Belmont Form-based Zoning Framework

July 2, 2024

**Responses to July 2 Memorandum
(For discussion purposes only)**

Half-story Building Heights

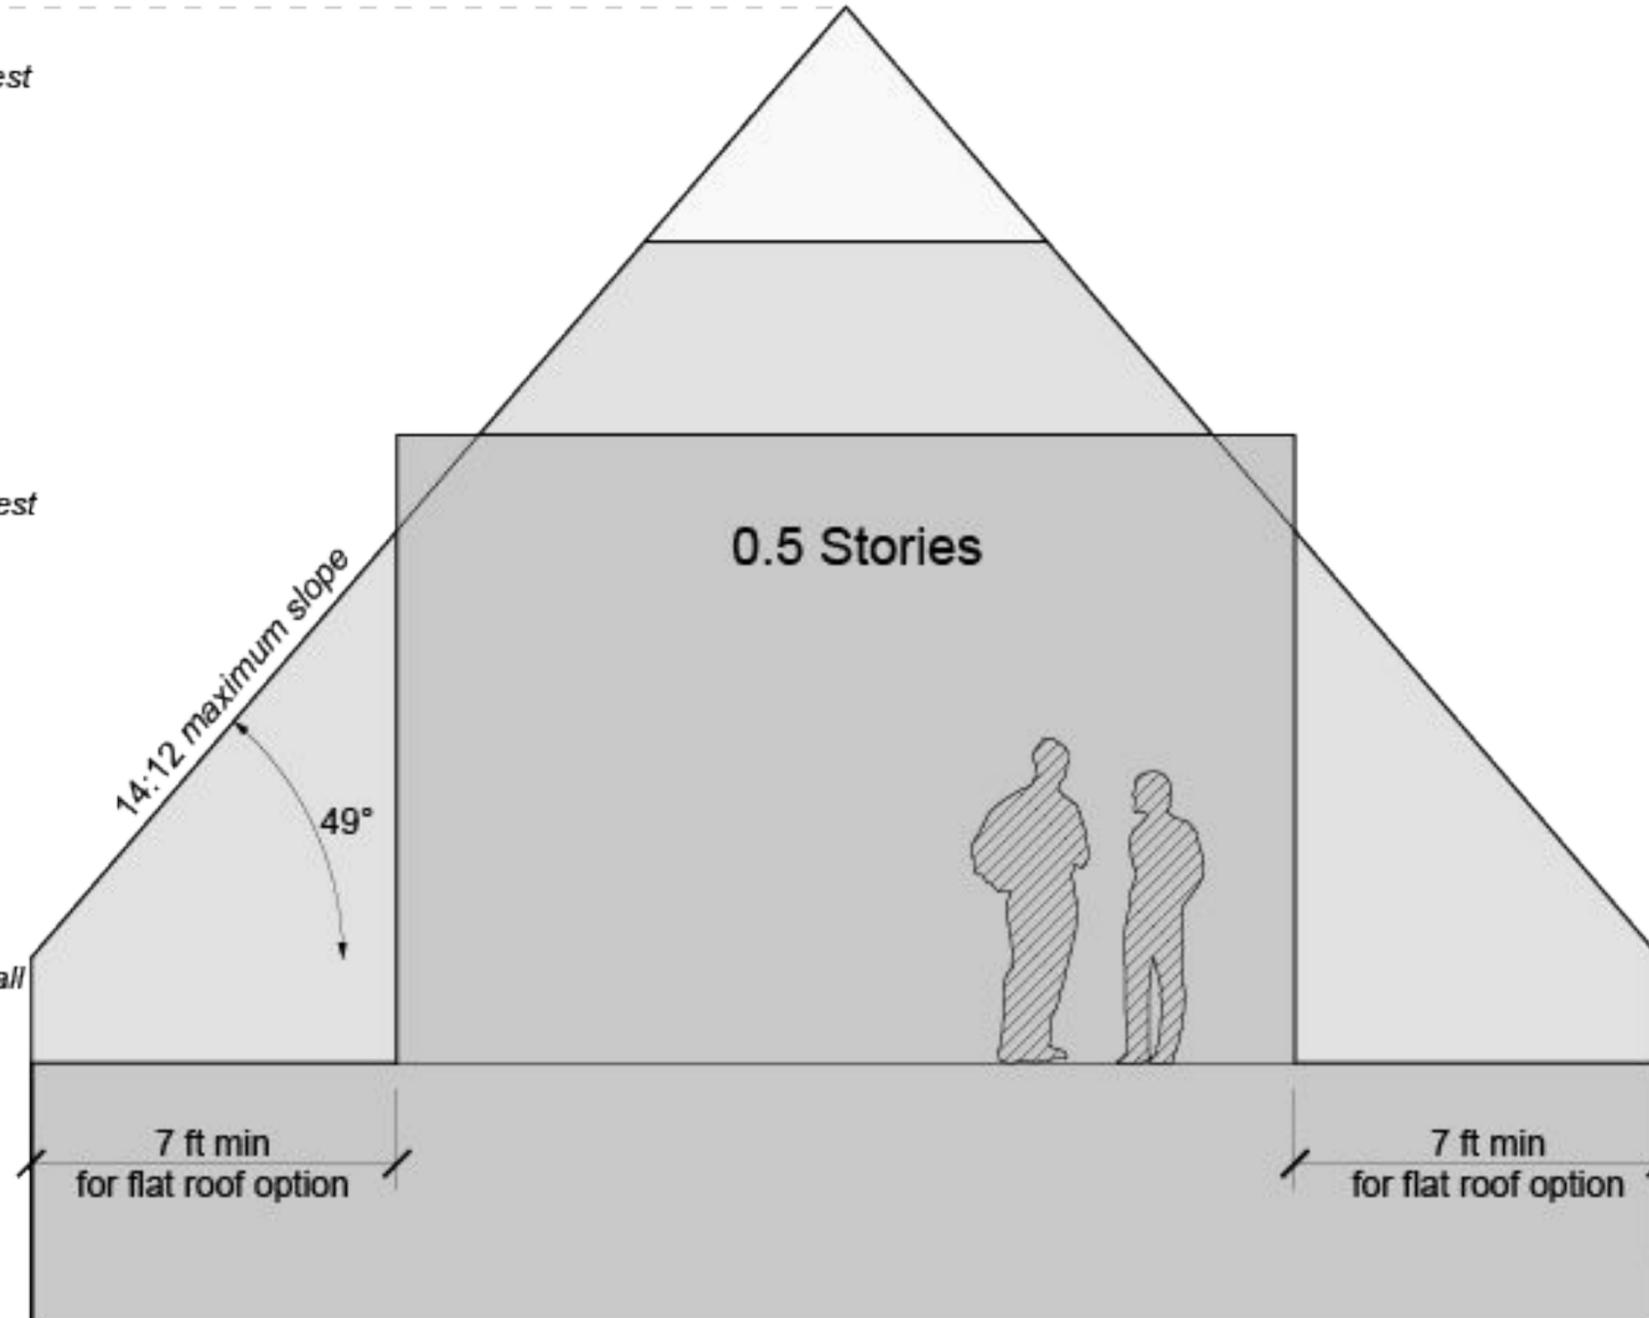
****P. 10, Building Height**, As currently defined, this is a maximum peak only on flat roofs. For pitched roofs, it is the average, so some peaks will be higher than the maximums listed. If that peak happens to be the one closest to an SR home, the fact that somewhere else on the site next door is lower will be little comfort to the abutter right next to the high point. (dk)

****P. 13, Graphic**, Will the images now be used in the other sections of the zoning bylaw as well? In some cases, the illustrated attributes seem to have exceptions. For example, the step back applies only on sides abutting SR lot lines. Further, at the 6/25/24 PB meeting, Thayer noted that the pitch on the roofs were steeper than what she normally sees and that the drawings looked off to her. (dk)

Utile response: See proposed building height measurement method.

Utile response: Need clarification of which graphic this is referring to

Questions about Façade Articulation

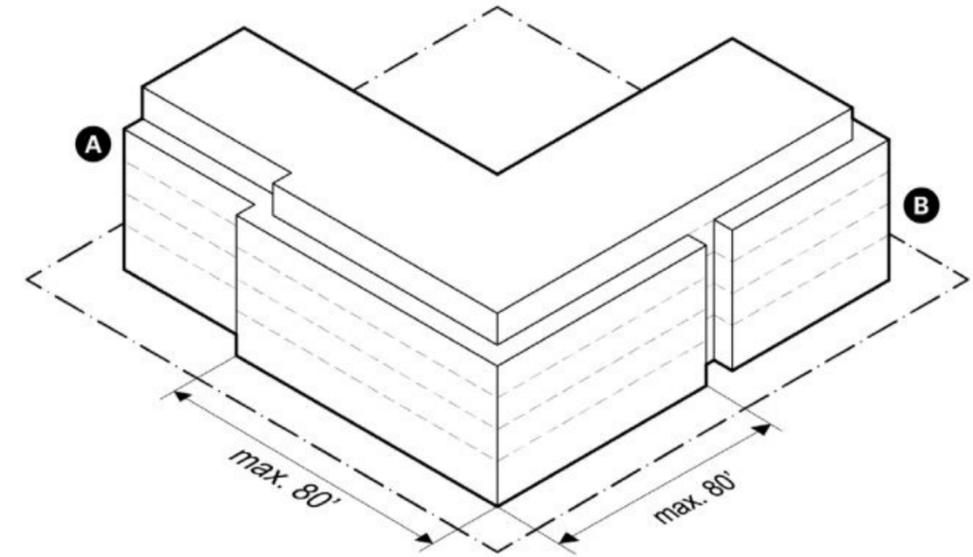
****P. 8, Length of Continuous Façade**, At the Bradford development, the approved designs had variation in the structure of the façade, such as bays and other approaches to break up the boring blockiness. This was all stripped out in their “value engineering” process once Toll Bros took it over. The language in this section should be evaluated in that context. Simply slapping on a different type of cladding to break up an otherwise uniform façade doesn’t cut it in my view. (dk)

****P. 21, Façade Articulation**, We should discuss facade articulation. I agree with the concept. I do not necessarily like the deep notch solution in the language. (td)

****P. 21, Façade Articulation, Sub 12.**, While the requirements for the front façade are helpful, the language for balconies is not. Cookie-cutter balconies along a massive rectangular building will still be boring and ugly, and do not have the same visual effect as the articulation and variation required on the front. (dk)

CJR: This will be passed along to Utile for comment. My guess is that in this case, uniformity in design and the provision of desirable leasable spaces is more important than articulation for its own sake.

Utile response: Open to re-evaluating which facade articulation rules are most appropriate for Belmont. Current draft provisions are as follows:

Questions about Definitions

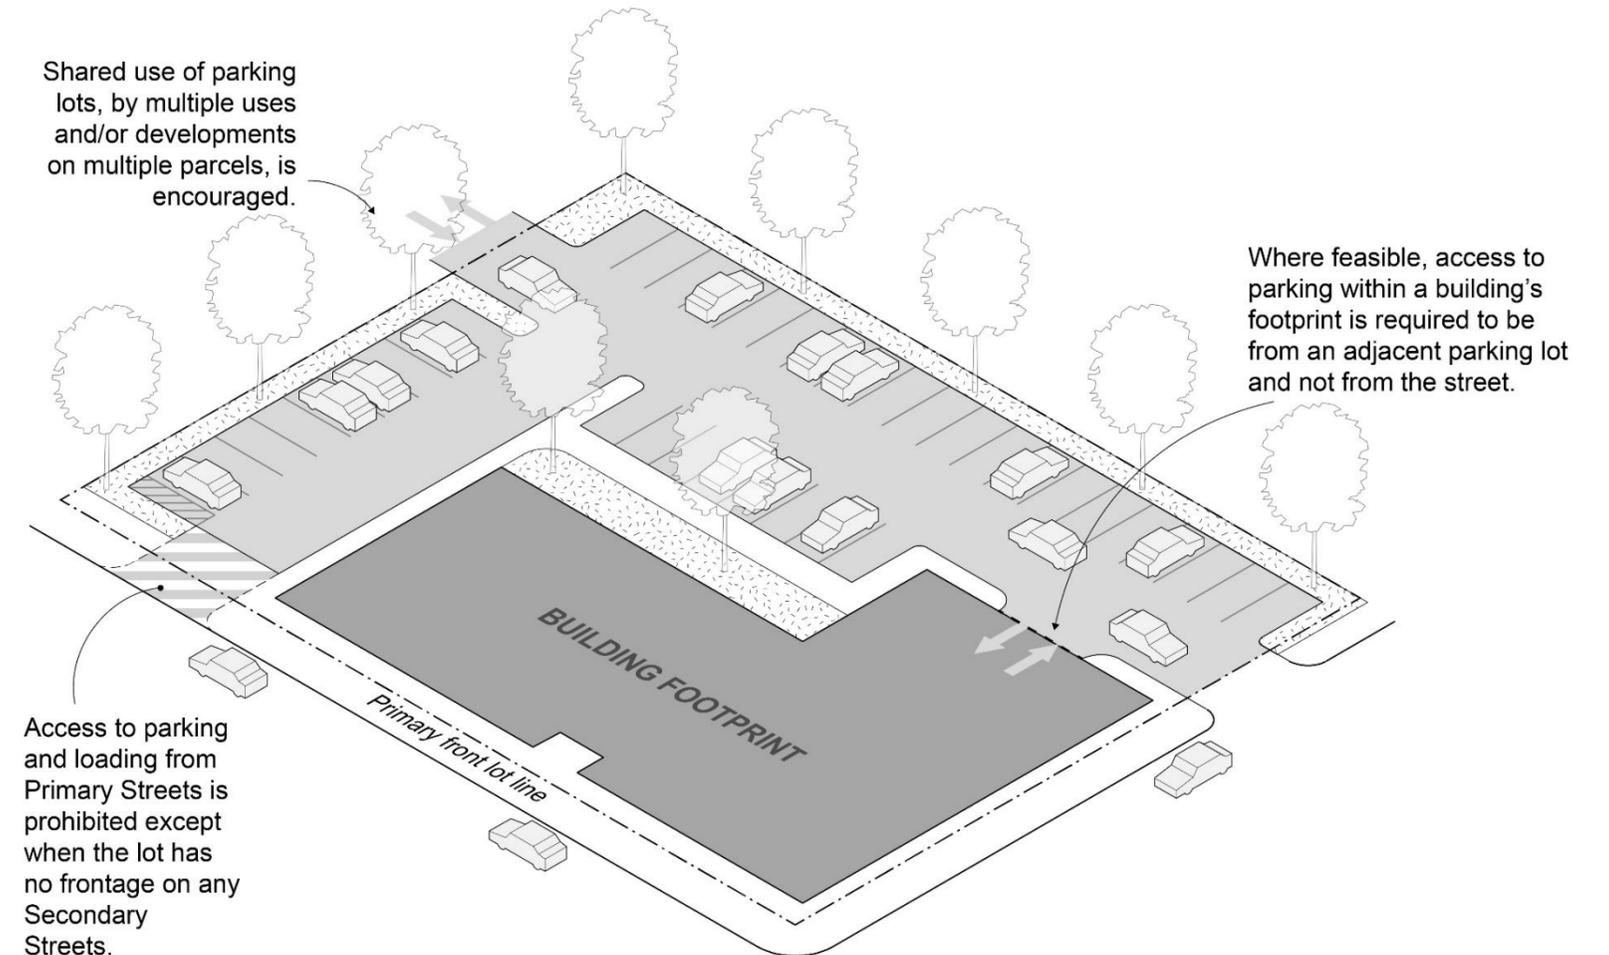
****P. 4**, Asked whether a better definition could be provided such as, "...rear lot line is the line that connects to two side lot lines?" or add that to supplement? (cjr)

****P. 4**, Is not "Lot Width" typically measured at the building setback line? (cjr)

Utile response: The definition in the draft text helps clarify which lot lines are considered side or rear lot lines in more ambiguous cases such as corner lot. Open to other ways of defining side and rear lot lines.

Utile response: Open to other ways of interpreting lot width.

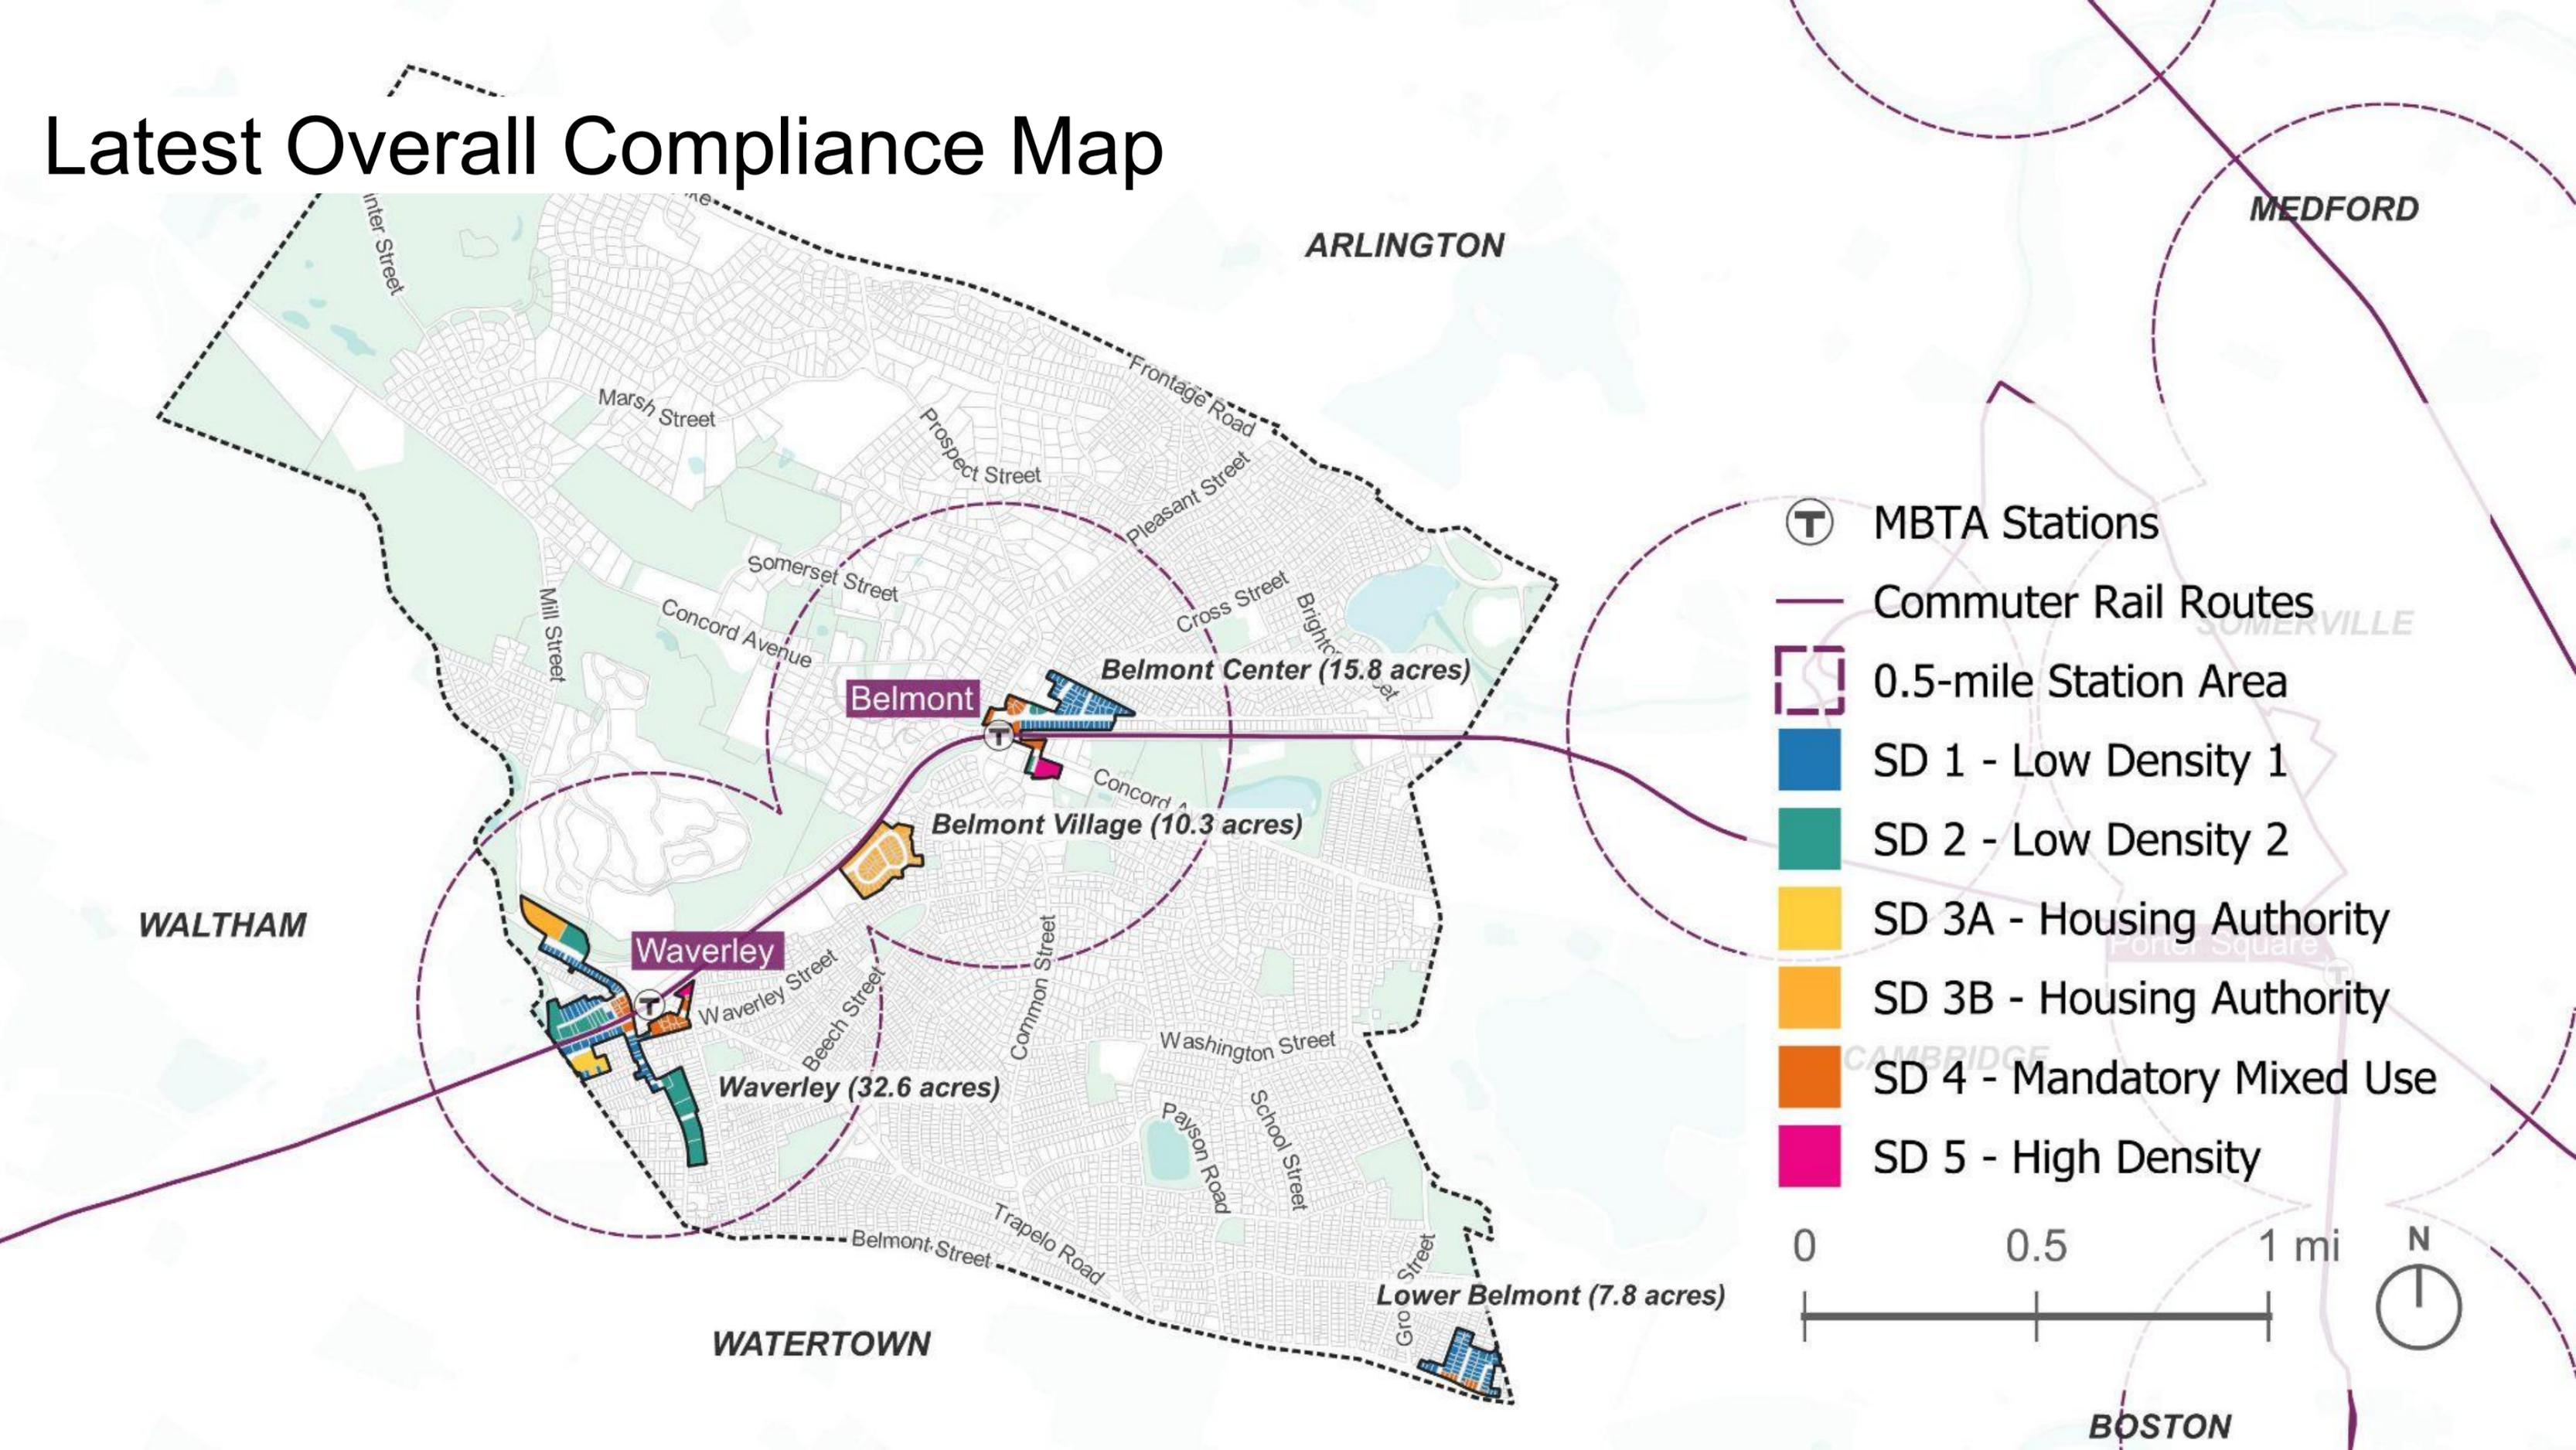
****P. 8, A2d**, What is this clause doing? Is it just clarifying that the least-restrictive setback rules apply? And if that is the case, wouldn't that mean that somebody could retain the underlying zoning (say, SR), but build it bigger and closer to the property line under this carve out related to 3A? (dk)

CJR: We have asked for additional clarification from Utile on this provision. Any provision like this still must be reviewed by Town Counsel, who may ask for additional clarifications.
